FORT ST. VRAIN NUCLEAR GENERATING STATION

AMENDMENT TO FACILITY OPERATING LICENSE

Amendment No. 60
License No. DPR-34

ATTACHMENT TO LICENSE AMENDMENT NO. 60

FIGURE 3.3-1

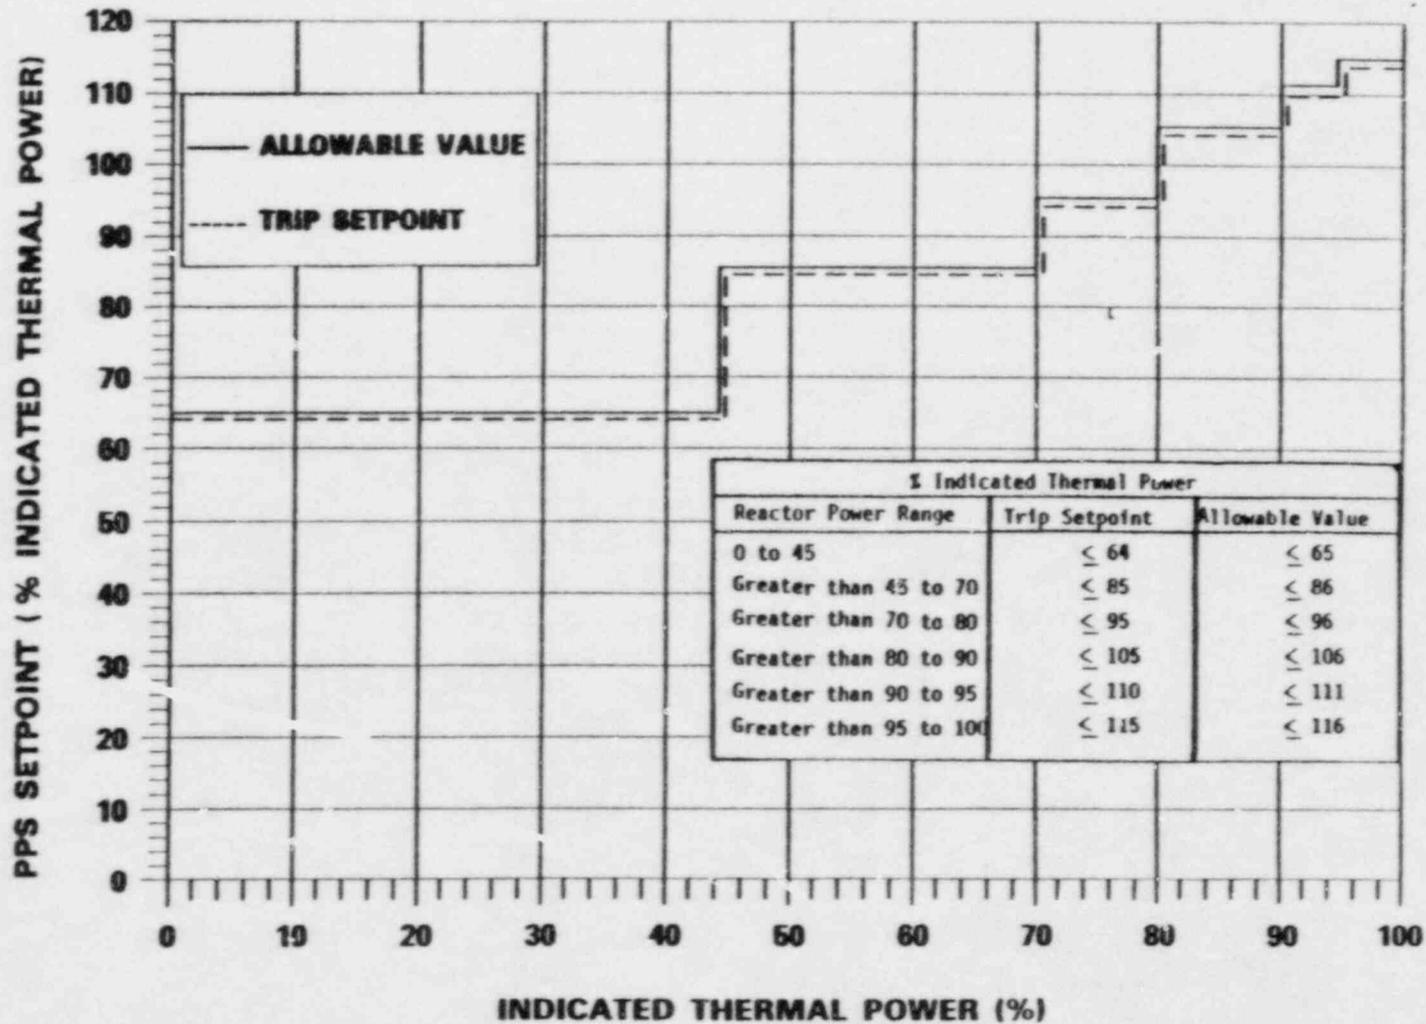
PARAMETER	FUNCTION	TRIP SETPOINT	ALLOWABLE VALUE
1. Reactor Core Limiting Safety System Settings			
a) Linear Channel-High (Neutron Flux)	Scram	Varies as a Function of Indicated Thermal Power per Figure 3.3-1	Varies as a Function of Indicated Thermal Power per Figure 3.3-1
b) Reheat Steam Temperature-High	Scram	< 1055 degree F	< 1067 degree F
c) Primary Coolant Pressure-Programmed Low	Scram	< 68.6 psf below normal, programmed with Circulator Inlet Temperature. Upper TRIP SETPOINT of ≥ 631.1 psia.	< 72.7 psf below normal, programmed with Circulator Inlet Temperature per Figure 3.3-2. Upper limit to produce trip at ≥ 627 psia.
